REPORT
TO
KERR ADDISON MINES LTD.
RE
SURFACE GEOTECHNICAL CONSIDERATIONS
ABO PROPERTY

Re: Geotechnical Considerations -
Abo property test adit

KERR ADDISON MINES LTD	
ABO. PROPERTY	
RN CLAIMS AREA	
PROPOSED TEST ADIT	
SCALE - 1 : 1000	DATE - AUGUST, 1, 1986
DRAWN BY - P.H., A.D.C.	DATA - T.B.
NTS - 92 H 5	REVISED - AUGUST, 25, 1986

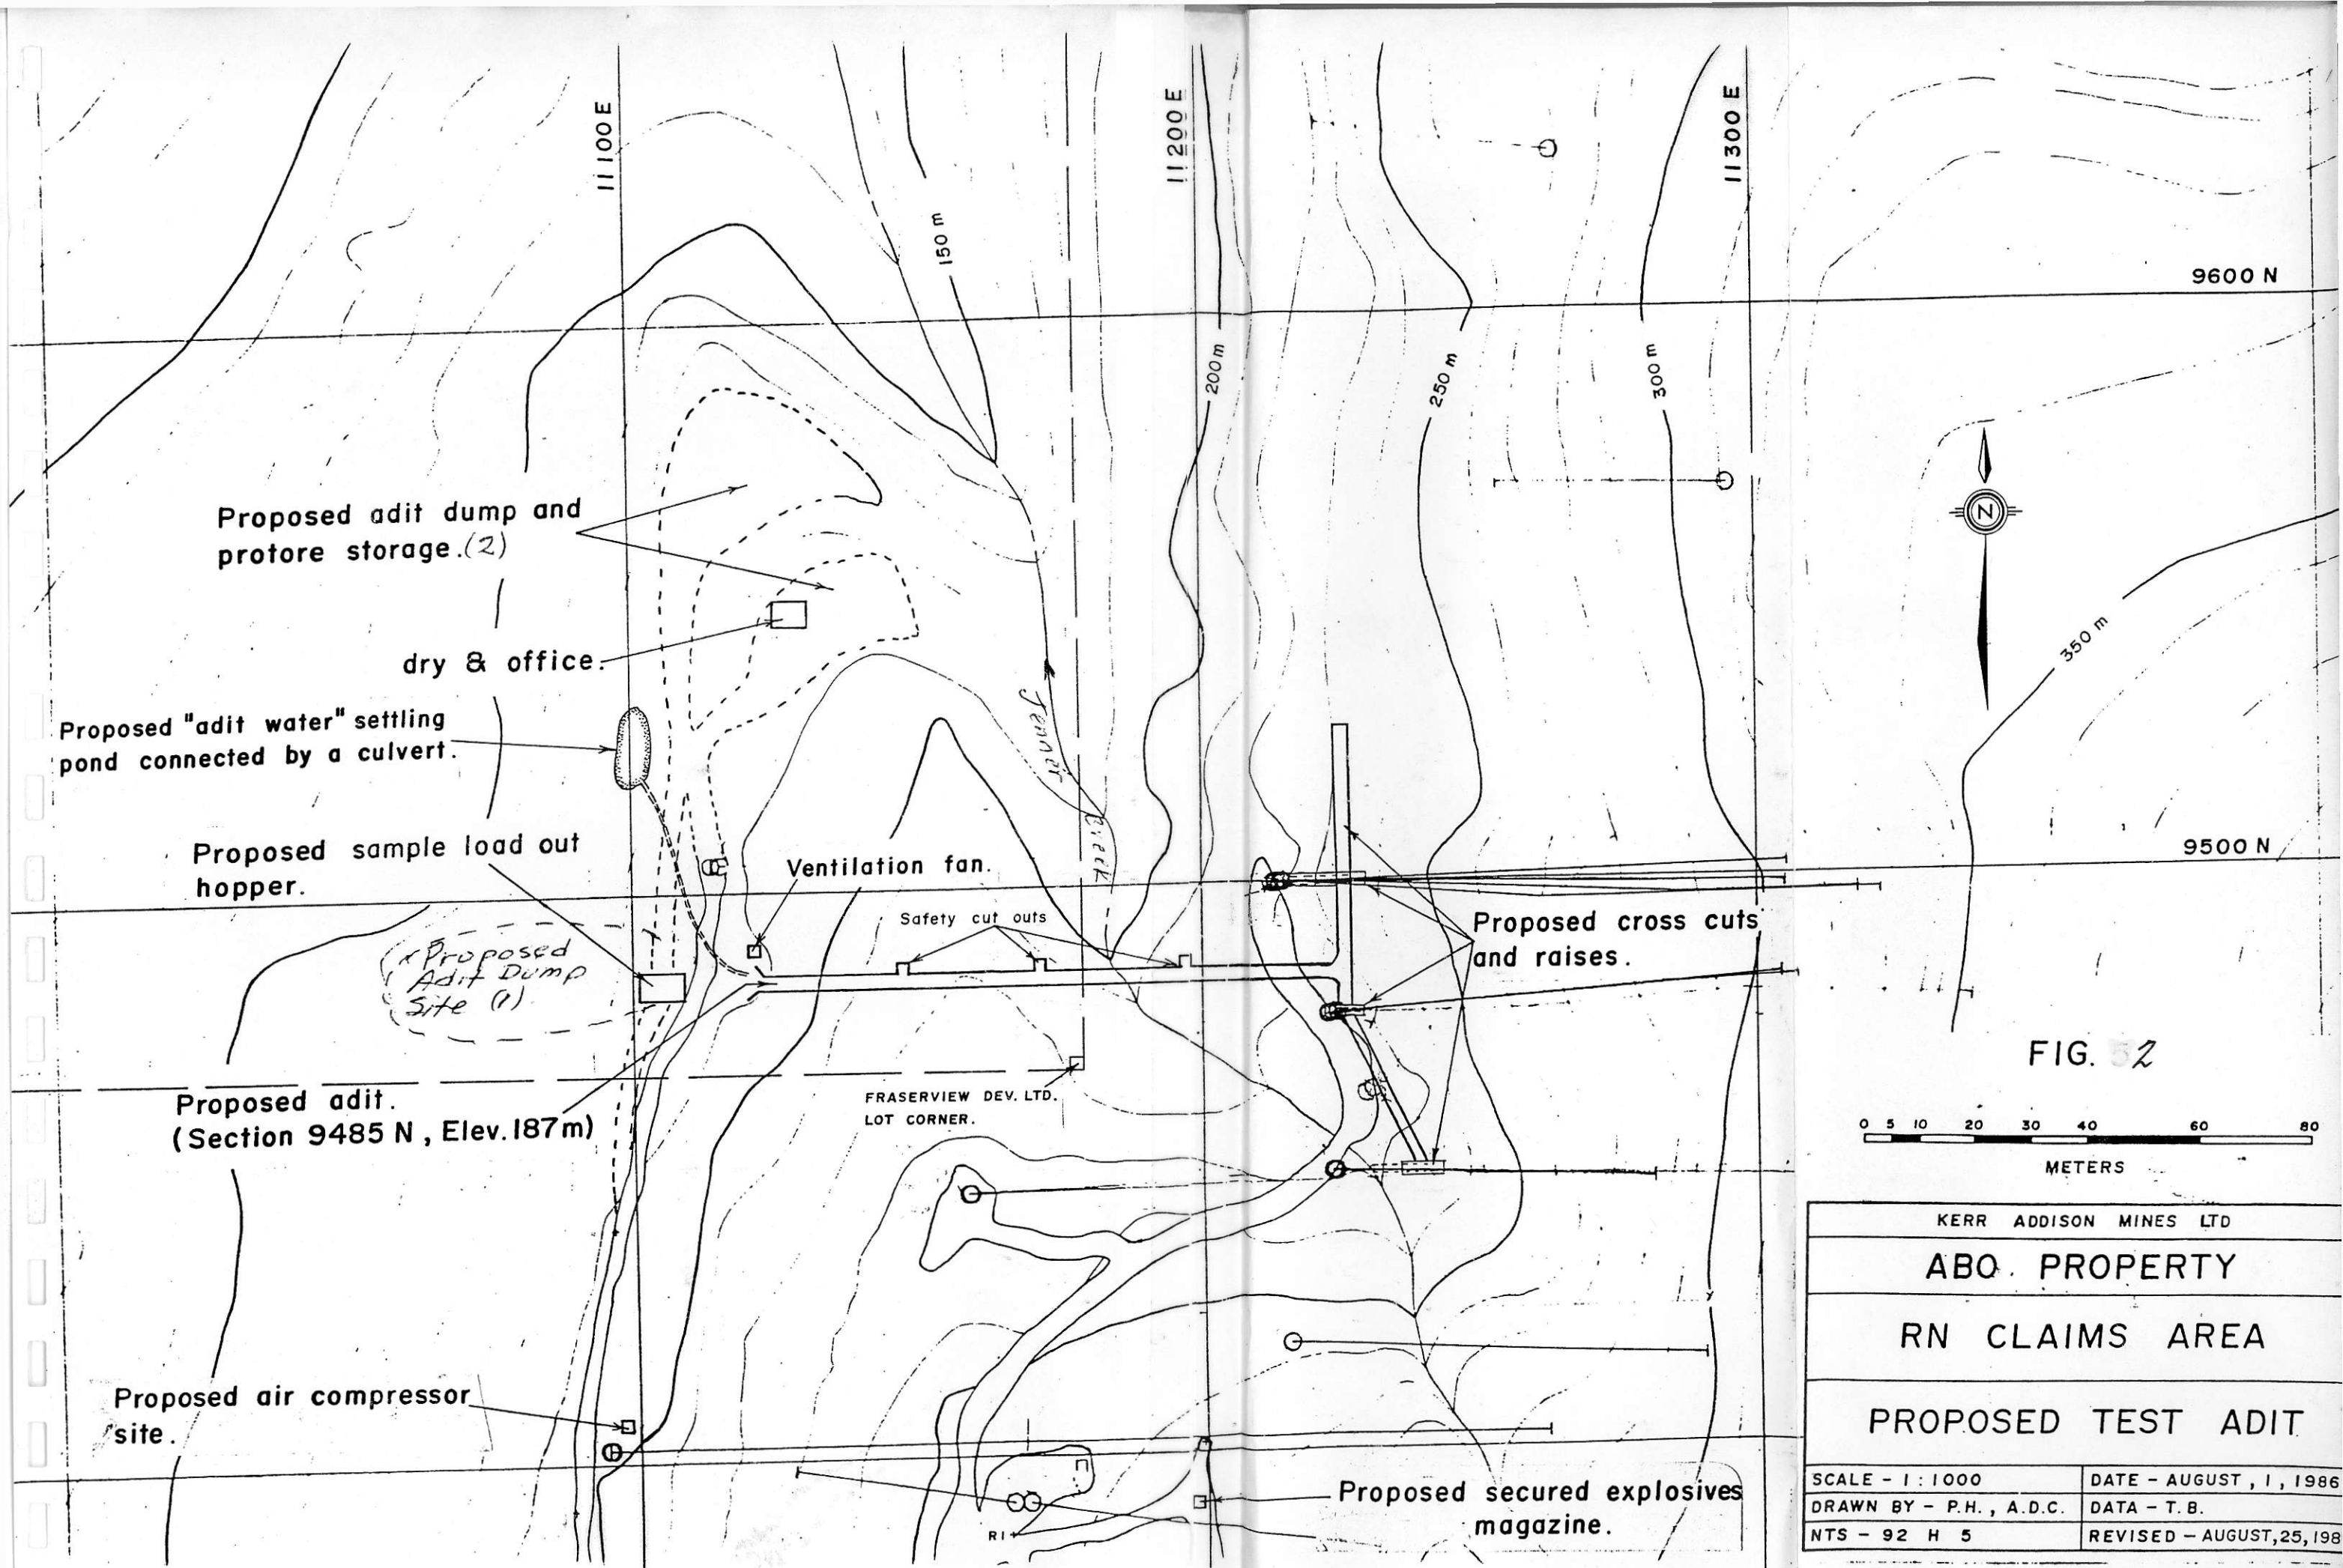
Figure 1 shows the site location and Figure 2 the proposed adit location. I understand the adit, cross cut and raises are intended to provide a 600 ton bulk sample of ore for testing.

The adit will extend under Jenner Creek about 60 meters in from the portal, Figure 5. This creek gully may be the surface indicator of a fault zone. If a fault does exist extra support and heavy seepage could occur. When the adit is being developed it is recommended that a percussion exploration drill hole be drilled ahead of the adit when it is about 10 meters from the vertical projection of the creek bed.
